UNITED STATES PATENT AND TRADEMARK OFFICE

Office Action Summary	Application No. 10/727,082	Applicant(s) BLUNDO, FRANK N.	
	Examiner Chi Q Nguyen	Art Unit 3635

DETAILED ACTION

Fig. 8.

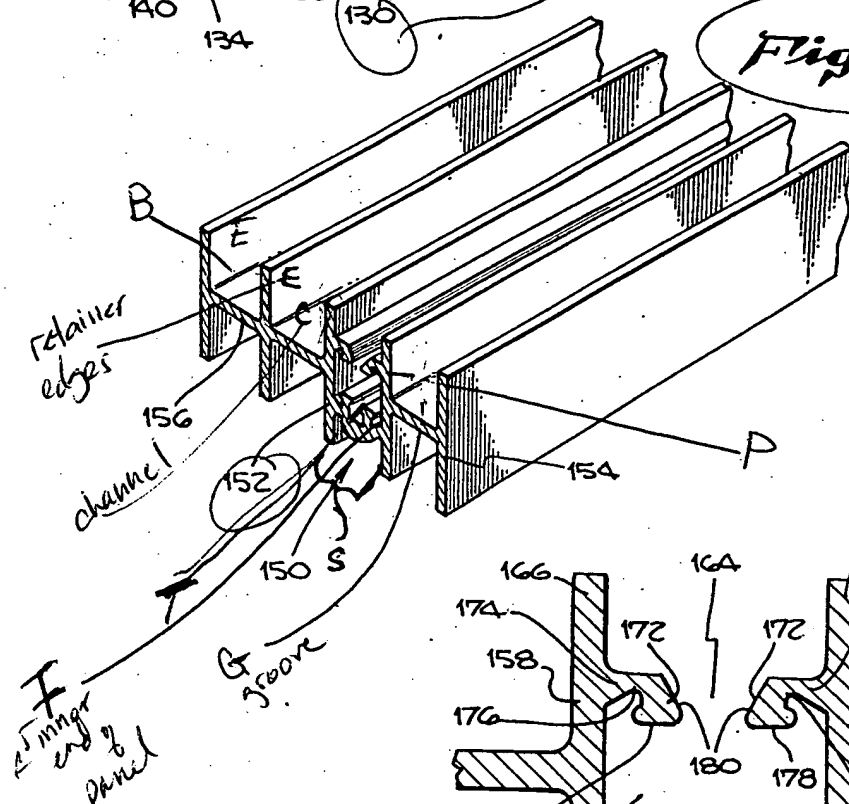
In regarding claim 1, Kay teaches a panel of thermal barrier extrusion 150 comprising at least one channel C (see attachment of figure 8) positioned on a side of the panel having retainer edges E on each side of the channel C, said channel extending the length of the panel 150, a thermally non-conducting section 130 (figure 7) of the panel located adjacent to the channel C and extending the length of the panel, an end section S (see attachment of figure 8) of the panel having a first end F attached to the thermally non-conducting section 130 and extending the length of the panel and a second opposite end P having an elongated slot G.

In regarding claim 9, Kay teaches a panel of thermal barrier extrusion 150 comprising a first side of the panel 150 having a first channel C (see attachment of figure 8), and a second channel B, said second channel being adjacent to the first channel, and the first channel and the second channel extending the length of the panel, each of said first channel and said second channel comprises retainer edges E on each side of the channels C, B, respectively, a thermally non-conducting section 130 (fig. 7) of the panel located adjacent to the first channel and extending the length of the panel, an outer end section having a first end F attached to the thermally non-conducting section 130 and extending the length of the panel, and a second opposite end P of the end section having an elongated slot G.

Applicant's arguments filed 4/20/05 that the Kay's prior art does not teach the channel having retainer edges have been fully considered but they are not persuasive because the applicant's claimed retainer edges do not structurally differentiate from the Kay's channel C or channel B, which inherently having retainer edges on each side as set forth above. Thus, the examiner believes the prior art teaches the claimed invention and the applicant's amendment does not overcome the prior art.
